# Accessibility Evaluation

## Monroe County Polling Location

**Bloomington High School North 3901 N Kinser  
Pike Bloomington, IN 47404**

**Report Date: 04/06/2026**

### Finding: 1

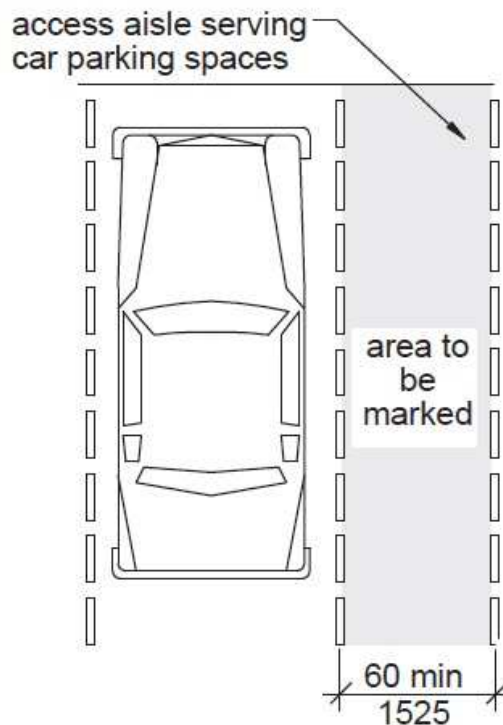
The access aisle is missing at the accessible parking space.

Access aisles serving parking spaces shall adjoin an accessible route. Two parking spaces shall be permitted to share a common access aisle.

2010 ADAS Section 502.2

Car parking spaces shall be 96 inches (2440 mm) wide minimum and van parking spaces shall be 132 inches (3350 mm) wide minimum, shall be marked to define the width, and shall have an adjacent access aisle complying with 502.3.

Recommend marking one or two spaces with cones to create access aisles. There are additional accessible spaces with access aisles slightly farther away from the ramp.

### Finding: 2

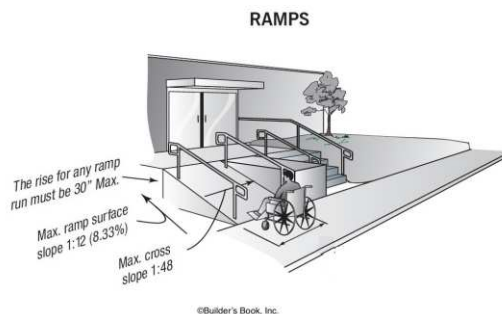
The ramps exceeds the maximum running slope (direction of travel) allowable of 8.33%. The slope was measured at 9 degrees, or approximately 15.8%.

Ramps should have the least possible slope but in no case more than 8.3% (1:12).

2010 ADAS Section 405.2

Ramp runs shall have a running slope not steeper than 1:12.

Add signage directing voters to park in the drop-off lane near the front doors if the ramp is too steep for them to climb. Add signage and/or cones in the drop-off lane to identify it as additional accessible parking.
